UTAH Knitting & Dyeing Ltd. (Extension)

Bokran-Monipur, Hotapara, Gazipur, Bangladesh
(24.125801, 90.389984)

06th January and 4th & 19th Feb 2020

Observations

Building 9 Mat Layout

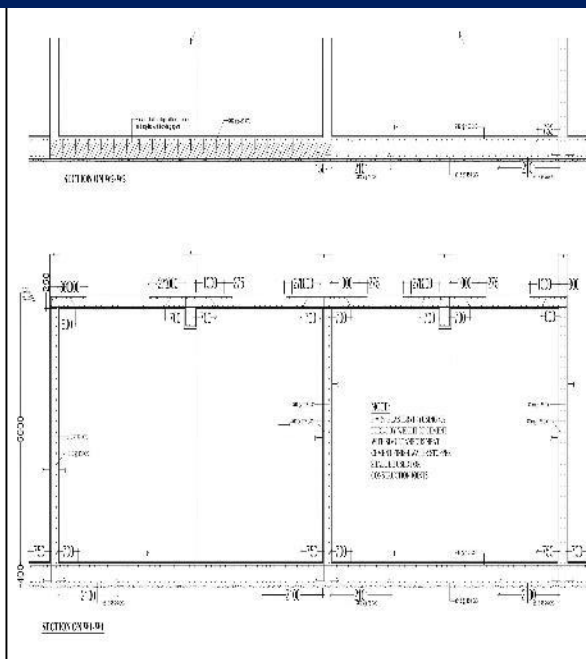
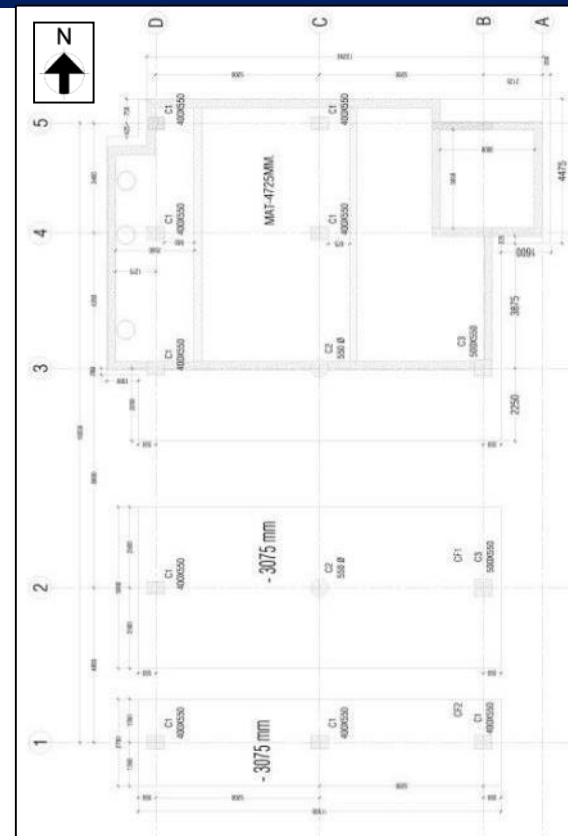
No geotechnical investigation report was found for the Building-9 Chemical Building (New), Building-10 (Thermo Oil Building) and Building-11 (Washing Extension Building). The factory management stated that, the geotechnical evaluation was done for the mentioned buildings based on the previous geotechnical investigation report that was produced for the factory buildings under ACCORD ID: 9533. But no bore hole sample for Building-9, 10 & 11 has been taken in the previous geotechnical investigation report . Thus, new geotechnical investigation report for the mentioned buildings is required to confirm the foundation adequacies for bearing.

Improper bracing system

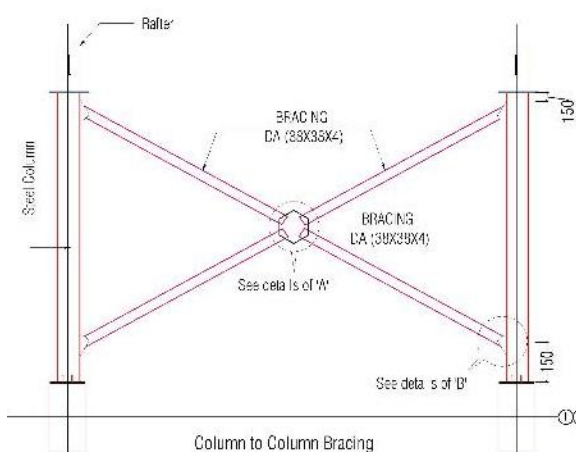
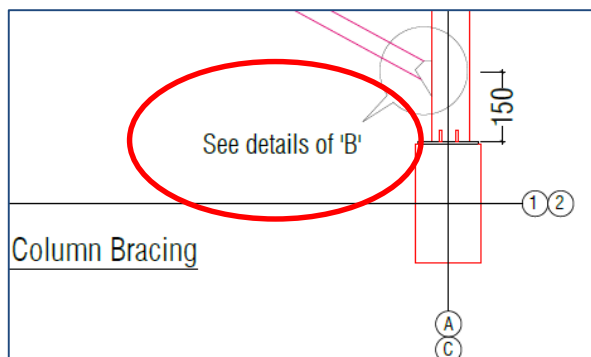
Some bracing has not been installed as per drawings. Details of bracing connection is missing in the drawing. Lateral load transfer mechanism between braced frames is not clear.

Lack of expansion gap between old and new Chemical Building

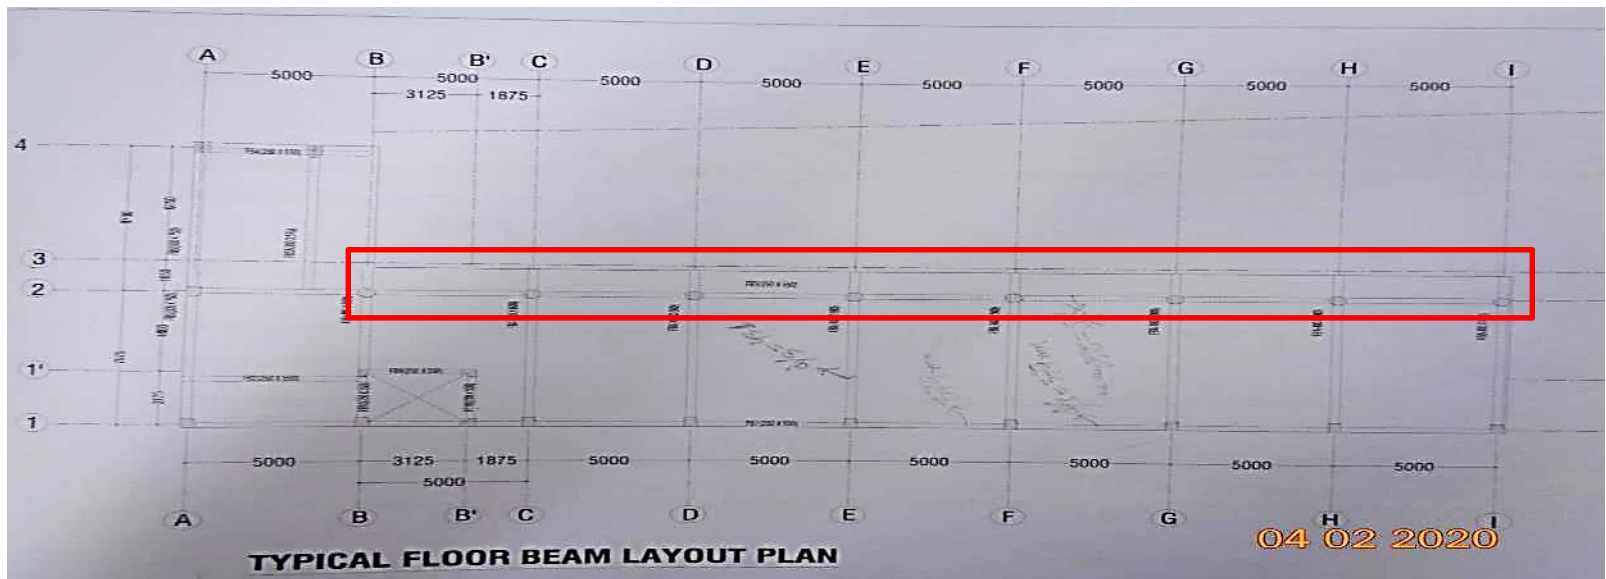
No gap provided between the old and new part of Chemical Building. The factory engineer is required to assess the maximum displacement of the building for the critical loadings and take necessary actions accordingly.

No gap has been provided

Discrepancies between drawing and as-built condition

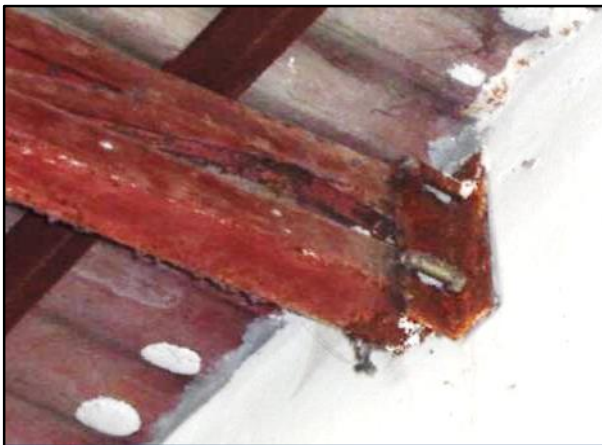
Cantilever beam was shown in the provided drawings but was not found on site at 1st floor level. The factory engineer is required to prepare “as-built” drawings with complete structural information.

Inconsistencies in drawings

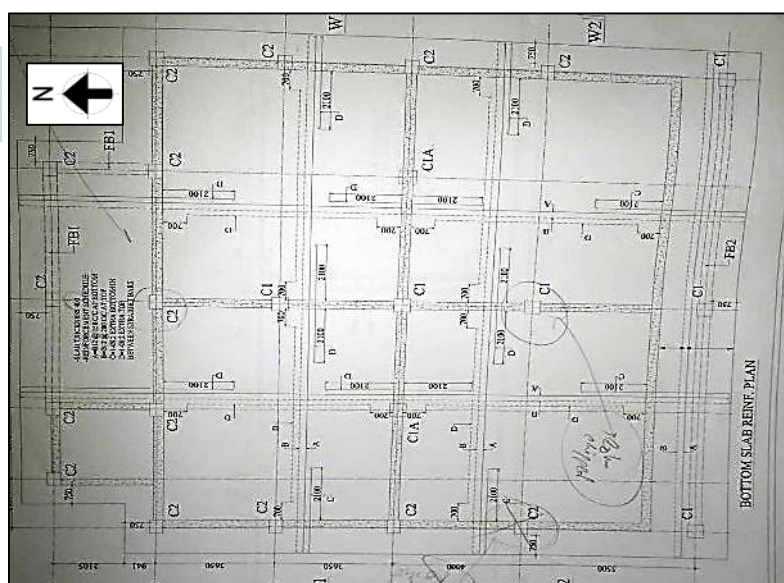
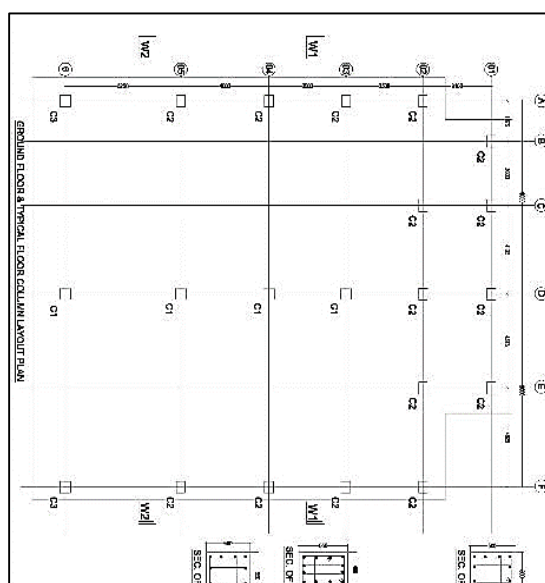
Mat slab reinforcement detail does not match with column layout of Thermo oil building.

Beam down stand of Washing building found 375 mm instead of 325 mm. The Slab thickness of washing building was found 200 mm instead of 150 mm. Some drawing as such lift core section, slab layout found missing. Revision of As-built drawing is required.

Column susceptible to impact load

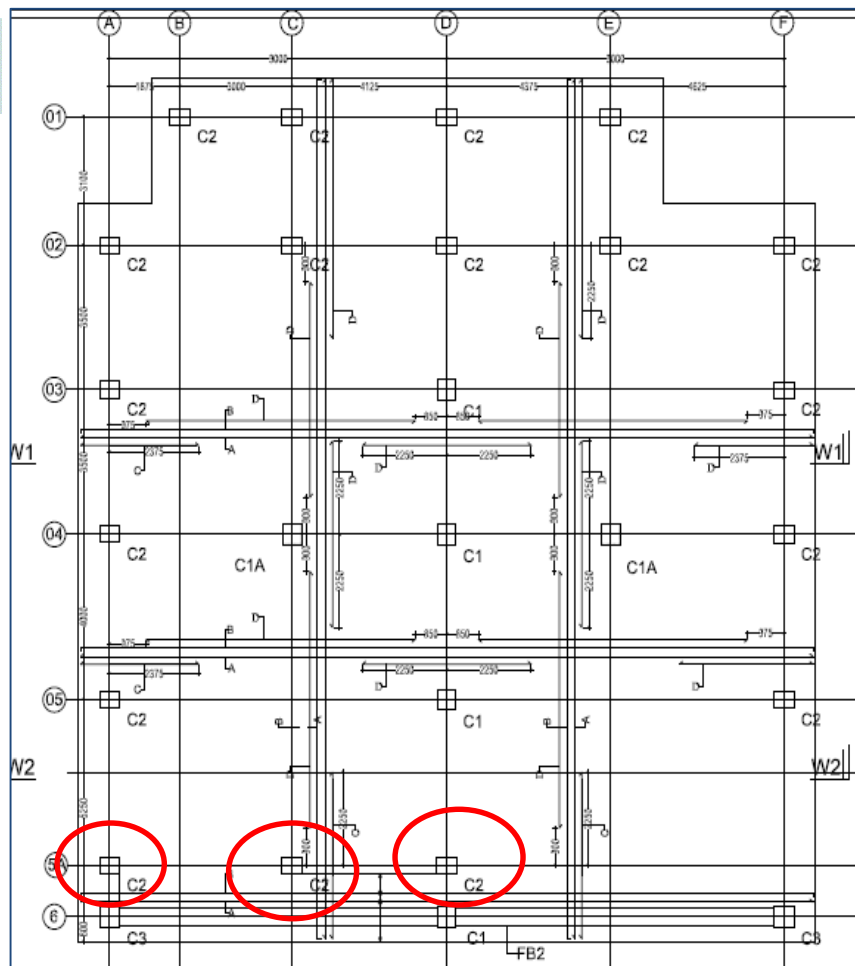
Columns are susceptible to impact loading from trolley. Signs of damage in columns were observed. Protection to be provided to the columns.

Mismatch between drawings and FEA model

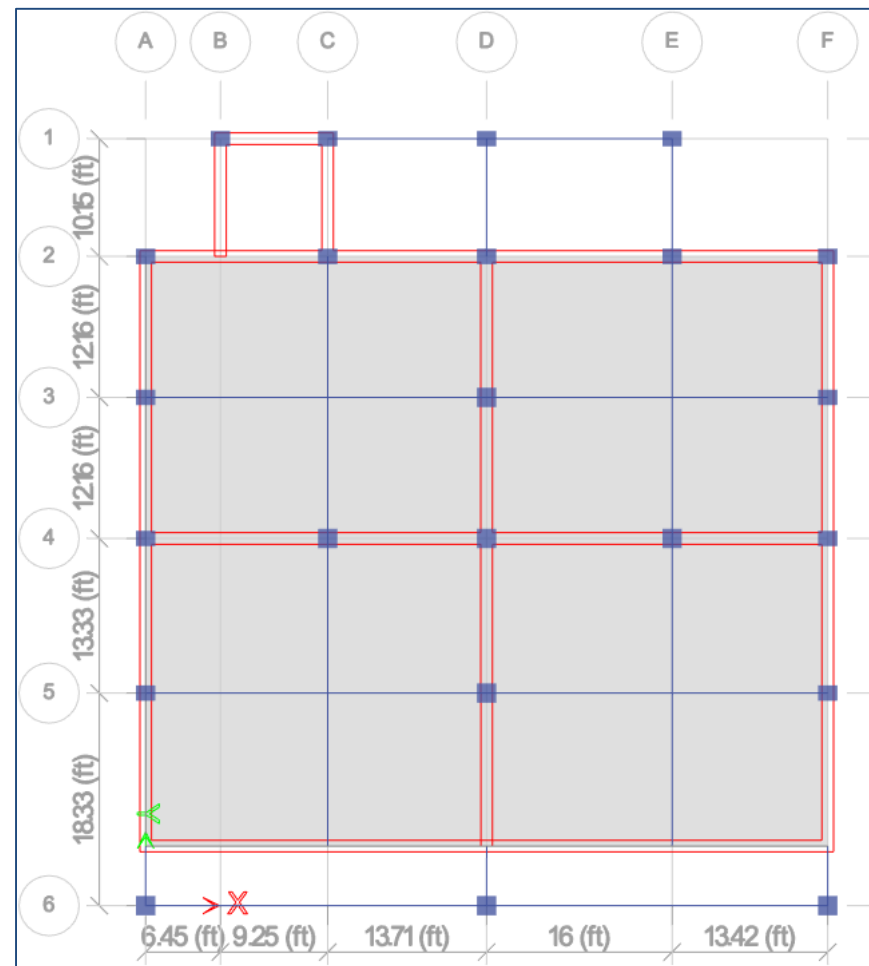
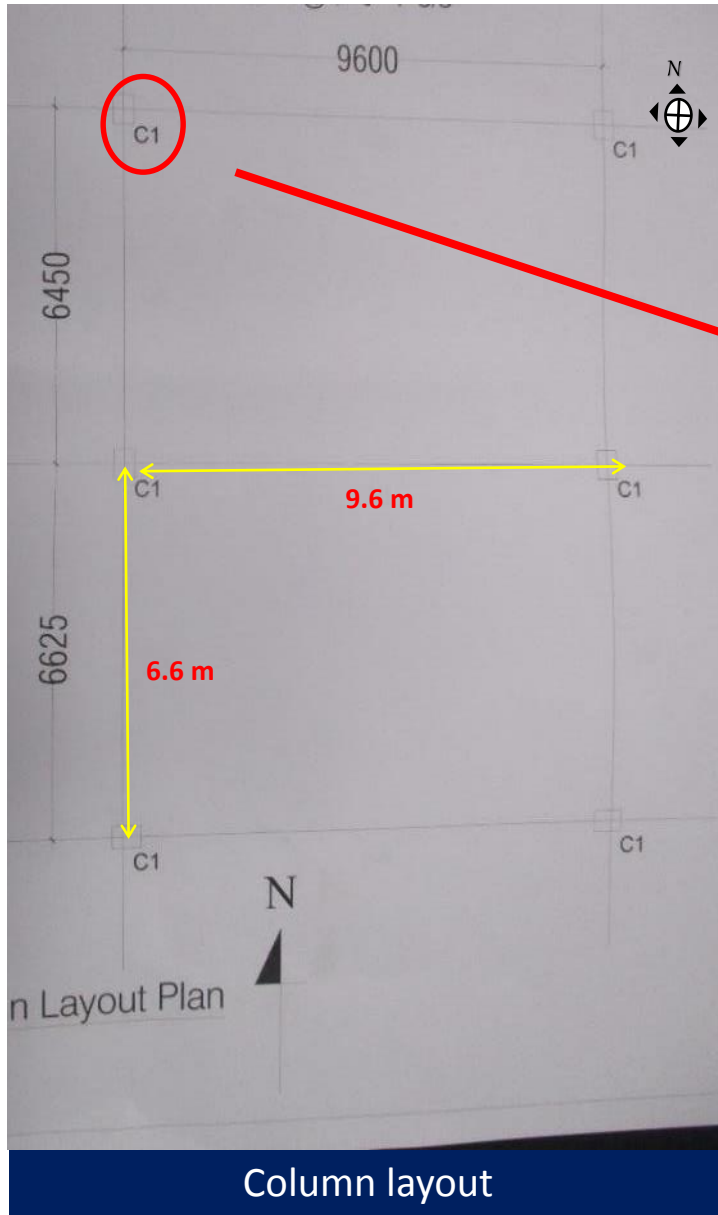
Marked Columns at basement level is shown in the drawing was not found in the provided FEA model that. The FEA model is required to be updated properly.

Crack in column

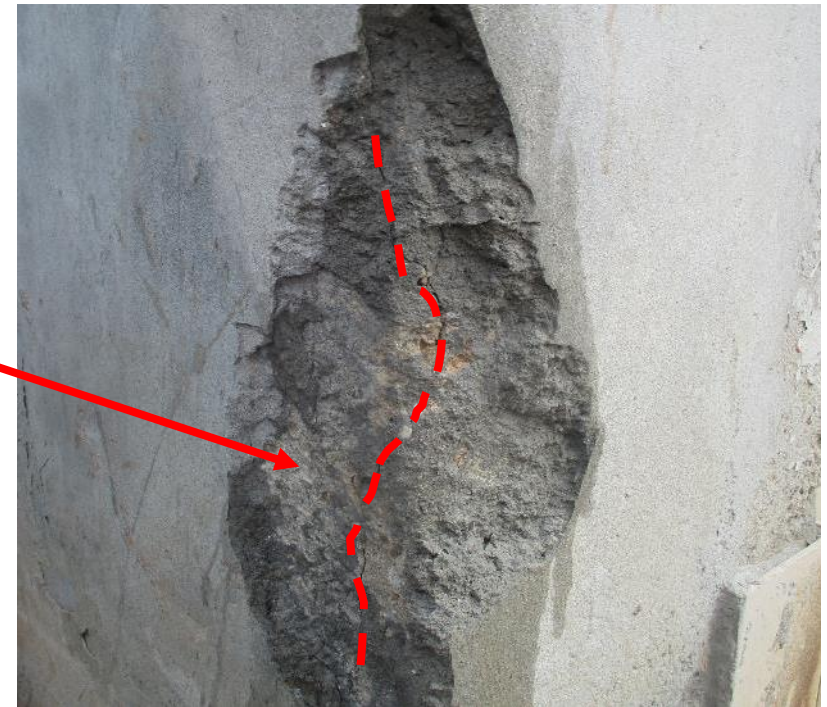
Crack found in concrete surface in the column at north-west corner (marked). The factory engineer is required to investigate the causes of crack and repair with a suitable method immediately.

Discrepancy between provided drawing and as-built condition

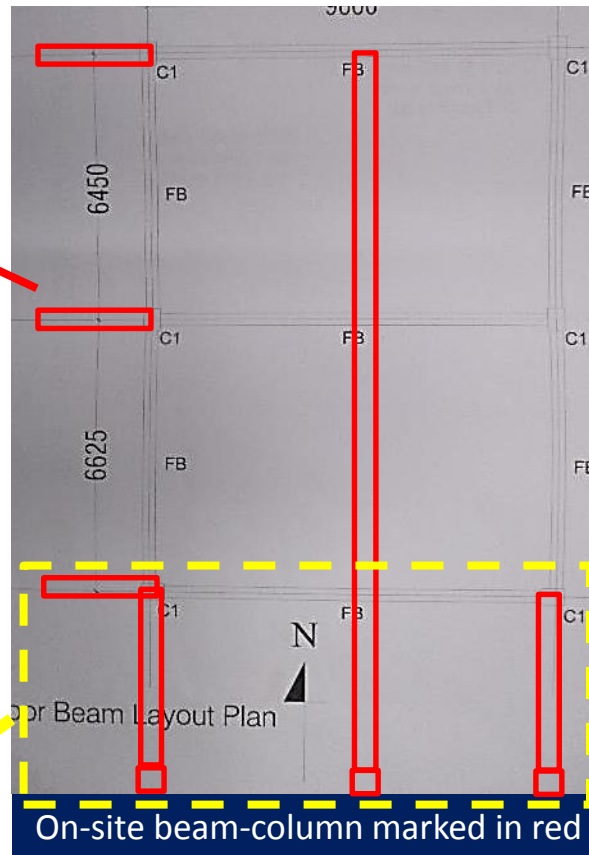
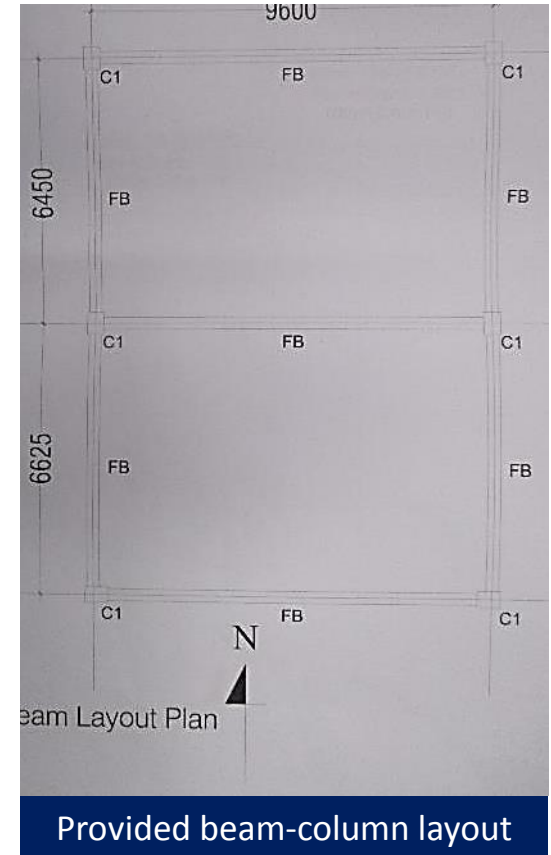
Provided beam-column layout didn't match with onsite condition. One extra bay was found connected with another building. The factory engineer is required to produce accurate as-built drawing and carryout Detail Engineering Assessment.

Unsupported long column

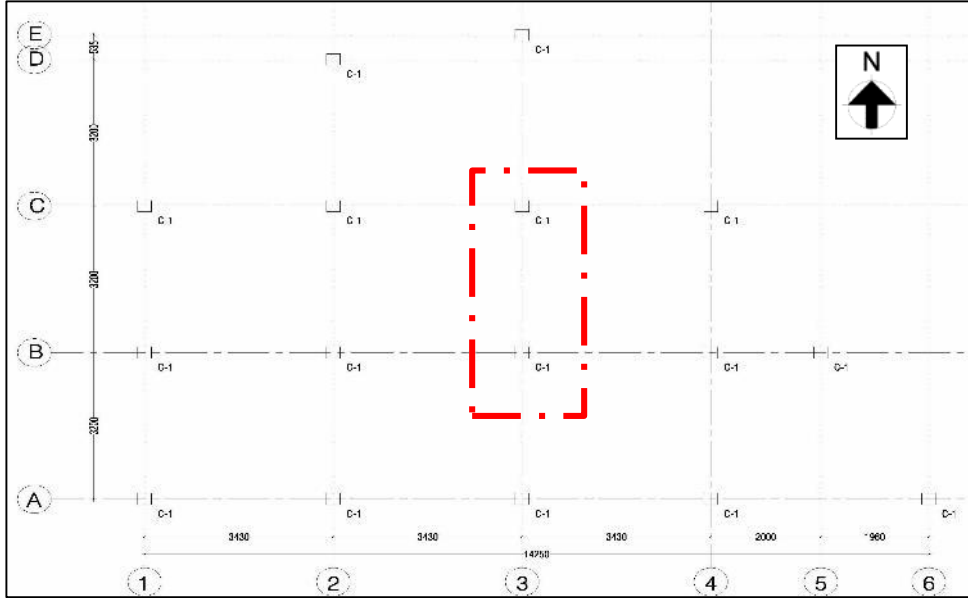
The column size is 500mm x 400mm and unsupported length is 5.88 m

The factory engineer is required to check the adequacy of the long columns as a part of Detail Engineering Assessment.

Inconsistencies in the provided drawings

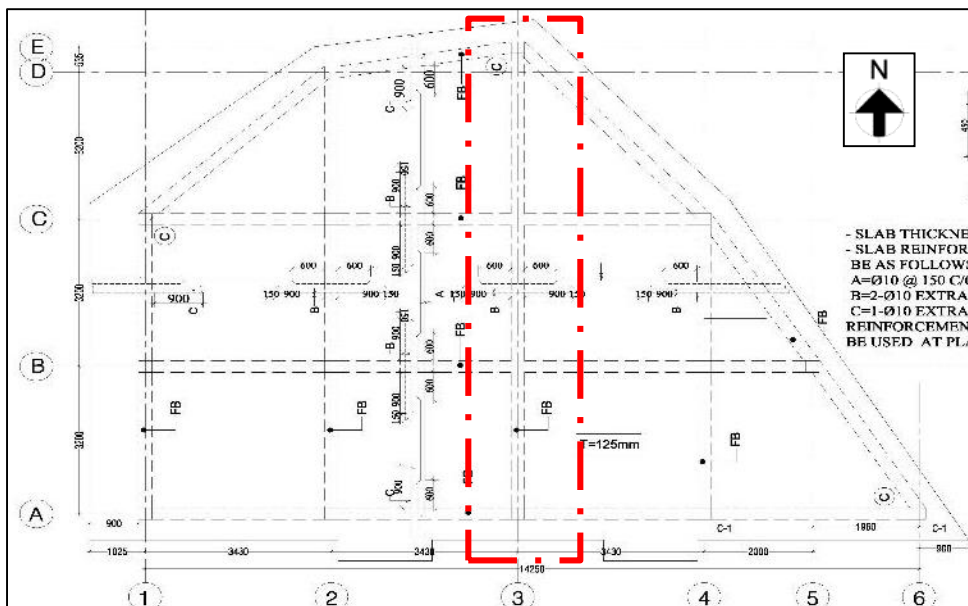
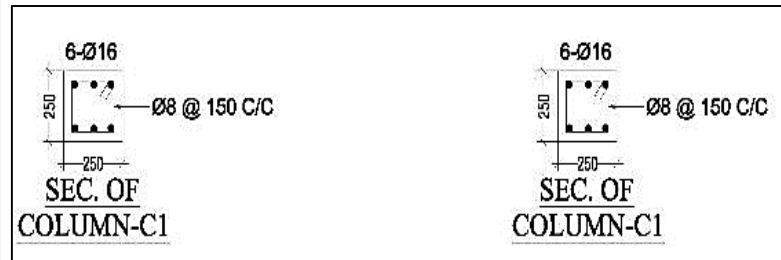
No columns and beam found in the marked location

6 rebars have shown in the column schedule where 4 rebars found onsite.

The factory engineer to survey the structure and update the as-built structural drawings accurately.

Absence of lateral load transfer media

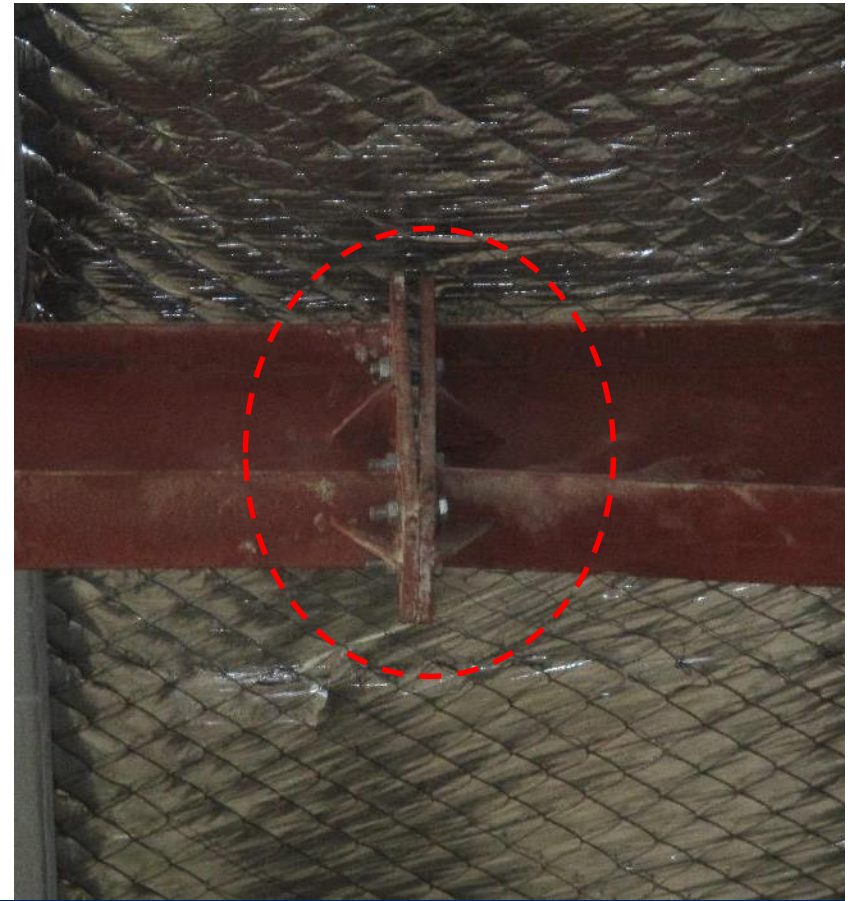
Lateral load transfer mechanism along long direction was absence. The factory engineer to carryout engineering assessment and design the lateral stability system for the structure.
